Tax ID #
ON-SITE SEWAGE DISPOSAL SYSTEM
HOWARD COUNTY HEALTH DEPARTMENT
BUREAU OF ENVIRONMENTAL HEALTH

SUBDIVISION: Chase at Stoney Brook LOT NUMBER: 2

ADDRESS: 182⁴ Irish Eyes Lane PROPERTY OWNER: Trinity Quality Homes

SCALE 1"=60'	DATE 08/13/10	ROBERT H. VOGEL ENGINEERING, INC. ENGINEERS - SURVEYORS - PLANNERS 8407 MAIN STREET ELLCOTT CITY, MARYLAND 21043 TEL:410-461-7666 FAX:410-461-8961	WALL CHECK DRAWING LOT 2 THE CHASE AT STONEY BROOK PLAT No. 18647 FOURTH ELECTION DISTRICT HOWARD COUNTY, MARYLAND
DRAWN BY A.M.S.	CHECKED BY T.M.H.		
PLAT NUMBER 18644-18649	JOB NUMBER 06-34.00

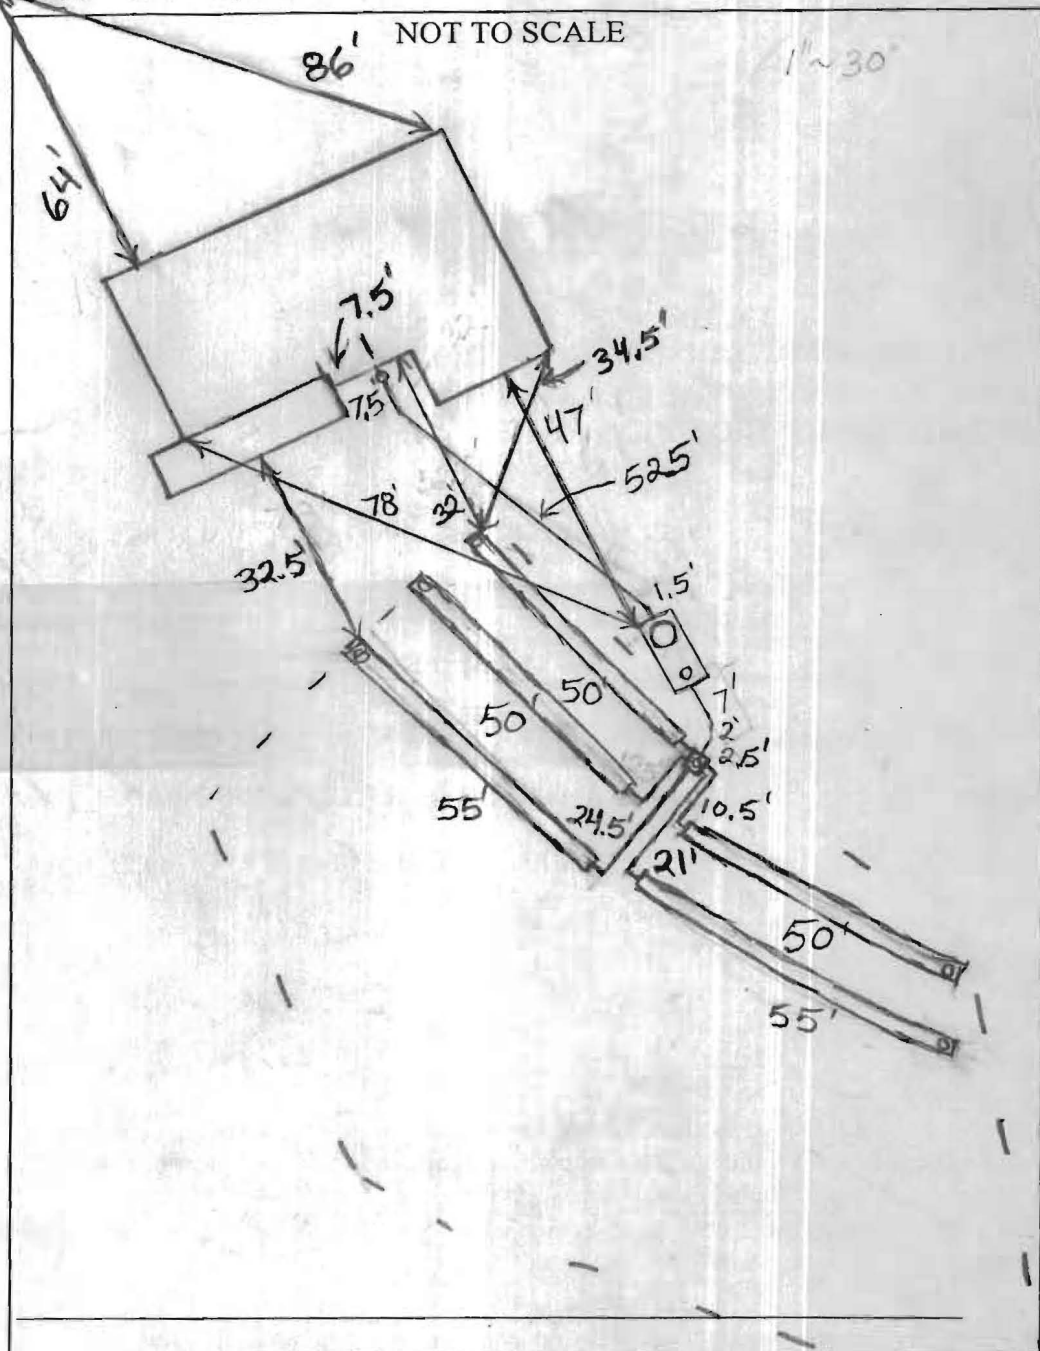
TRENCHES:	Trenches to be 3.0 feet wide. Inlet 4.0 feet below original grade. Bottom maximum depth 6.0 feet below original grade. Effective area begins at 5.0 feet below original grade with 2.0 feet of stone below distribution pipe.
LOCATION:	Run 3 x 45' trenches and 3 x 50' trenches on contour. Set d box @ top middle of easement per plan.
NOTES:	Do not order the septic tank until after layout inspection and Sanitarian approval. Stake easement corners. Call for layout inspection. Mark utilities. Gravel tickets must be available for Environmental Sanitarians. Stone must be approved by the Howard County Health Department. A written variance request is required for tanks deeper than 3 feet. A traffic bearing lid is required for tanks deeper than 4 feet.

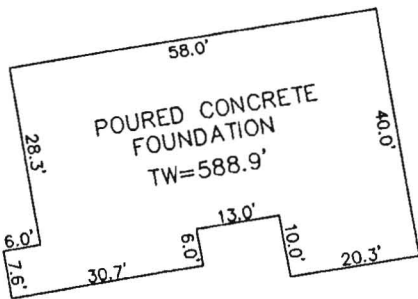
PRE-CONSTRUCTION
 10/12/2010 Large amount of fill on easement near house. Easement not staked. Remove fill and continue

layout when staked. O.K. to set tank (BB)

DETAIL: 1"=30'

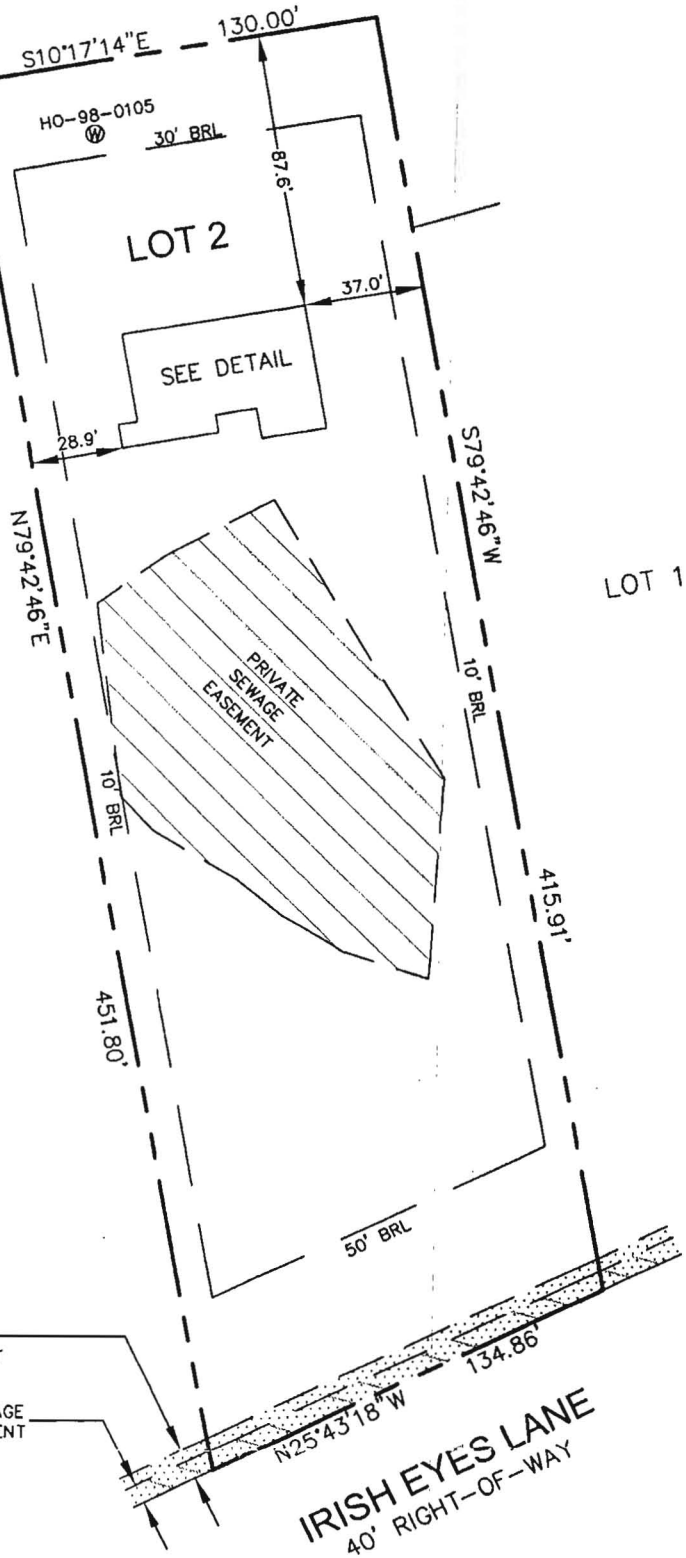
House has moved considerably by has set backs. DB 8-26-10 Wall check ok
